Docket No. 010077

Serial No. 09/775,894

AMENDMENTS TO THE DRAWINGS:

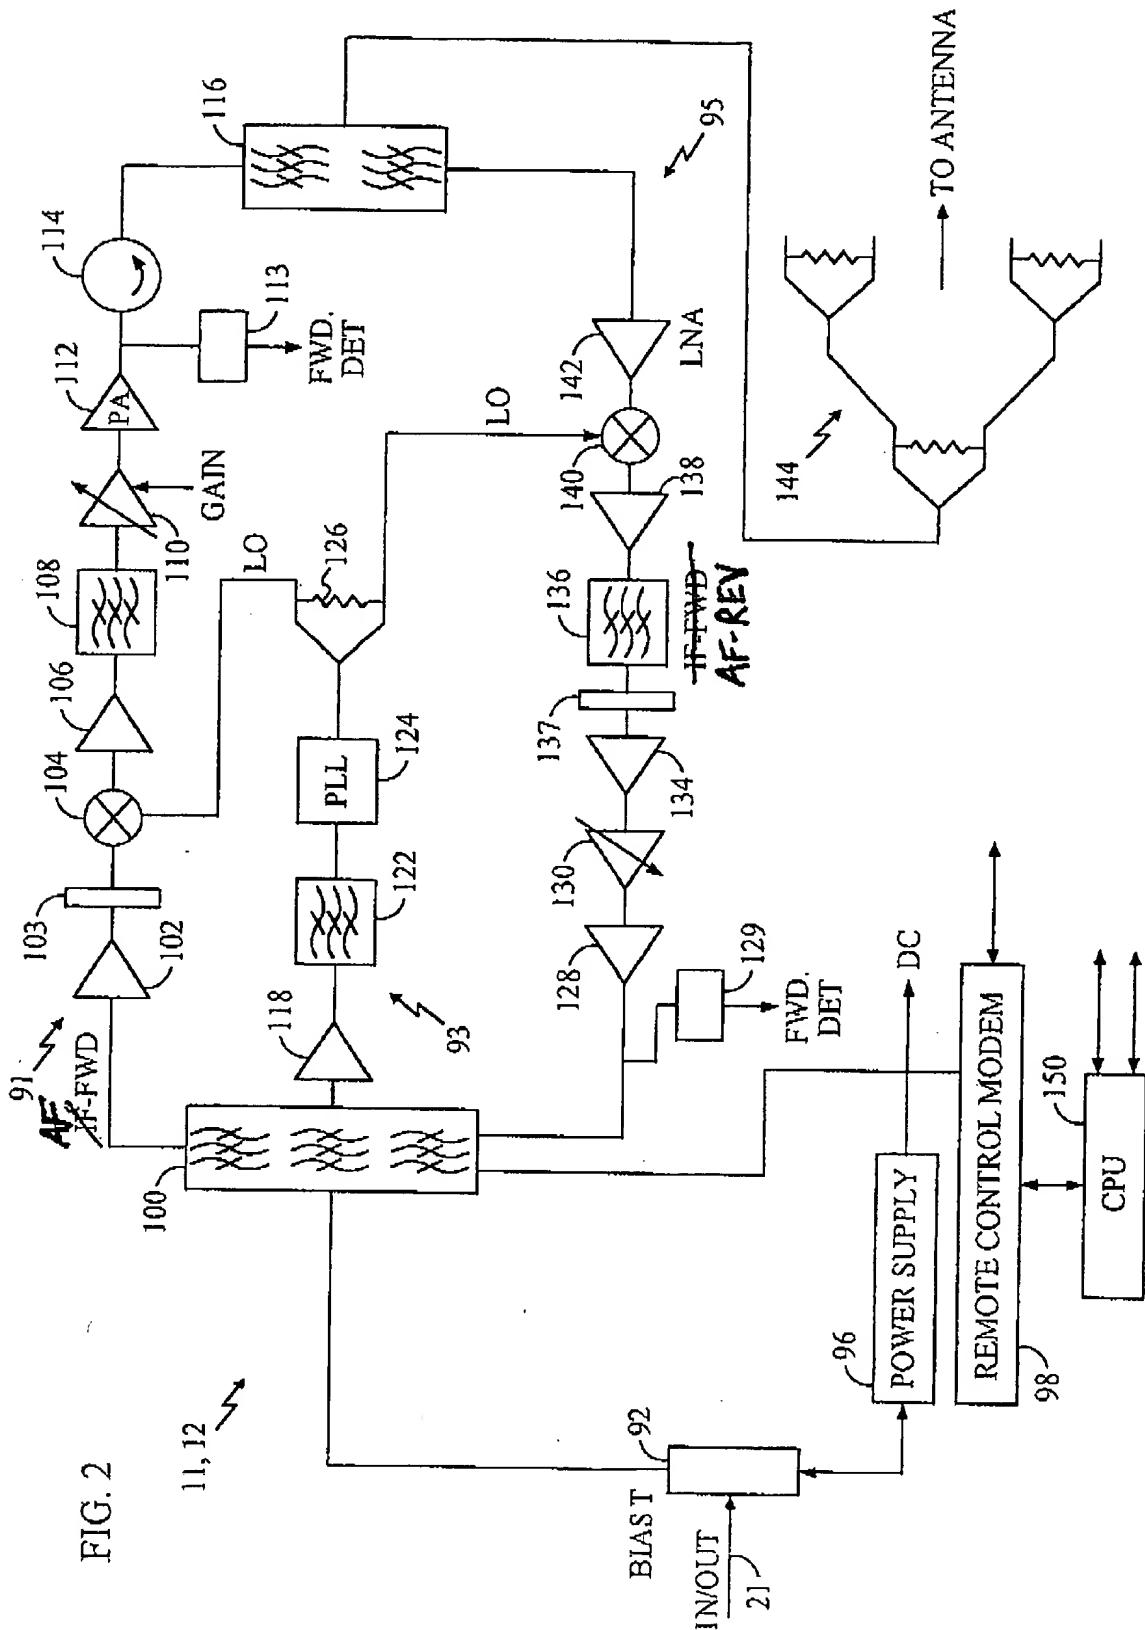
In Figure 1, box 26 and 32, "IF" was changed to "AF" in accordance with the specification (see page 10, lines 28-30, and page 11, lines 16-19.)

FIG. 2

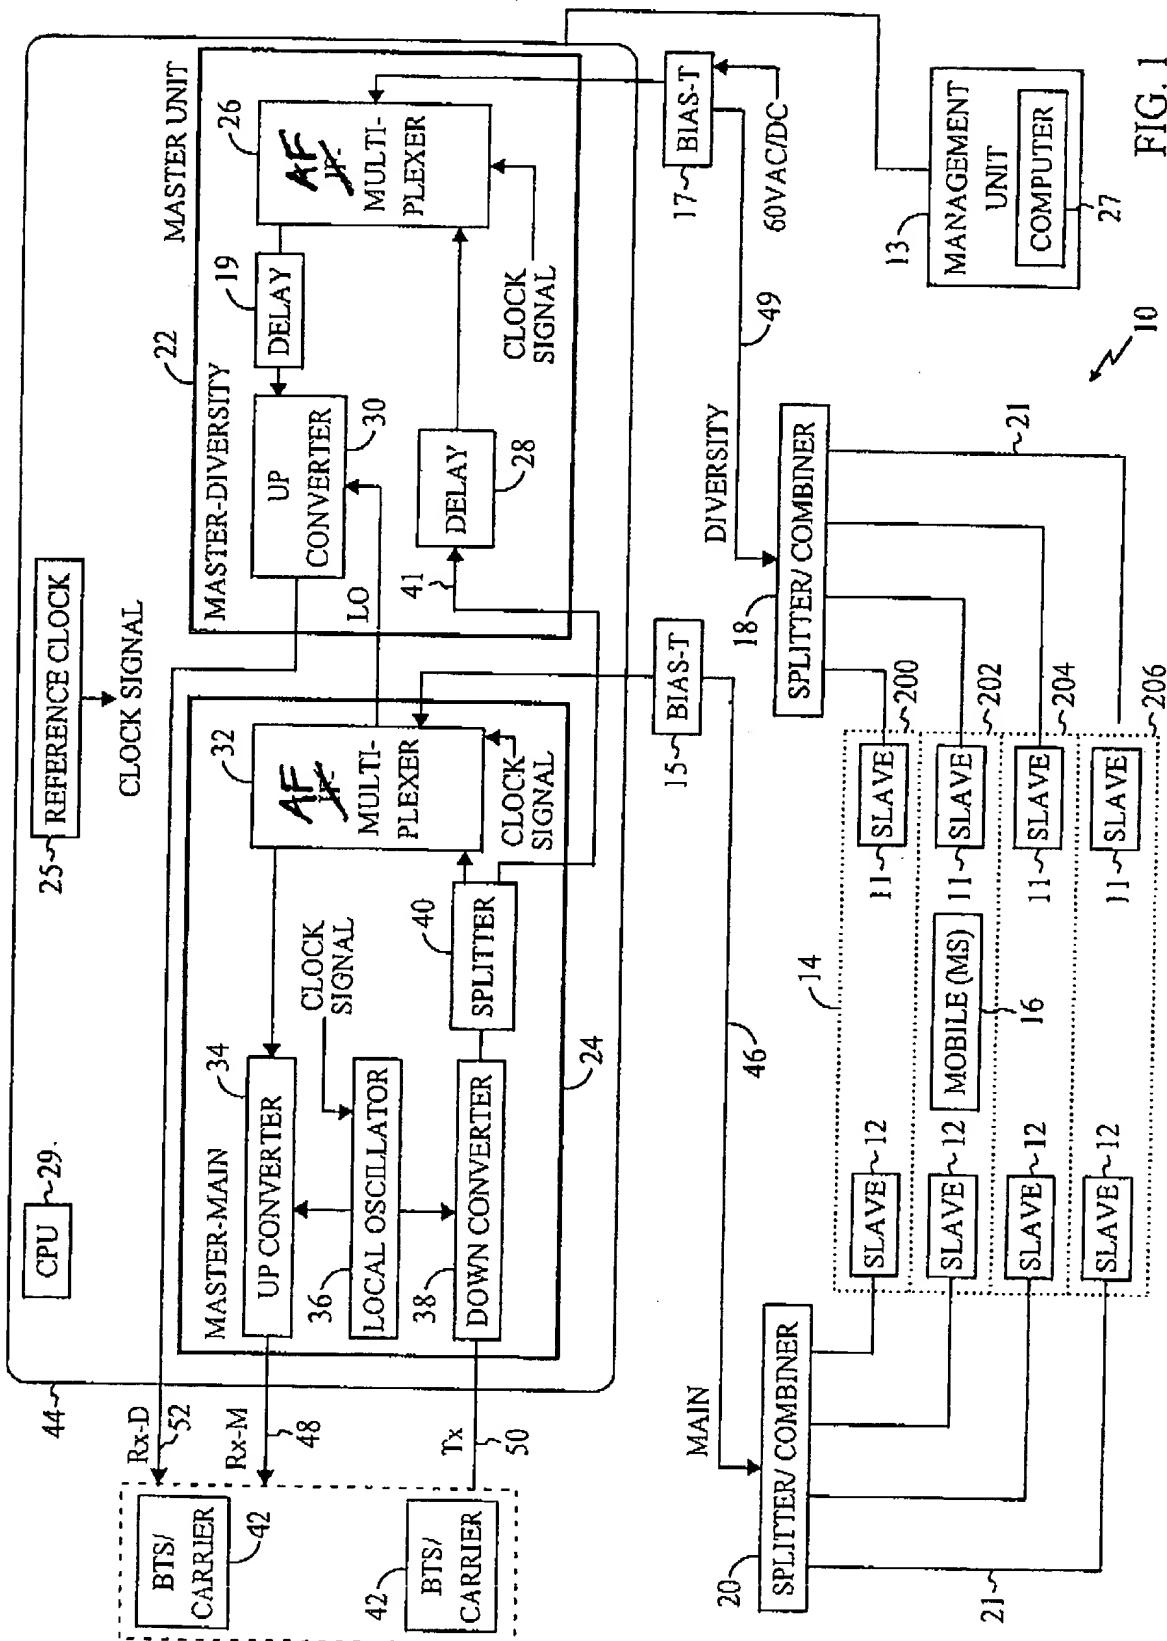
In Figure 2, near box 91, "IF" was changed to "AF" and in box 136, "IF-FWD" was changed to "AF-REV" in accordance with the specification (see page 14, lines 25-26, and page 15, lines 29-32.)
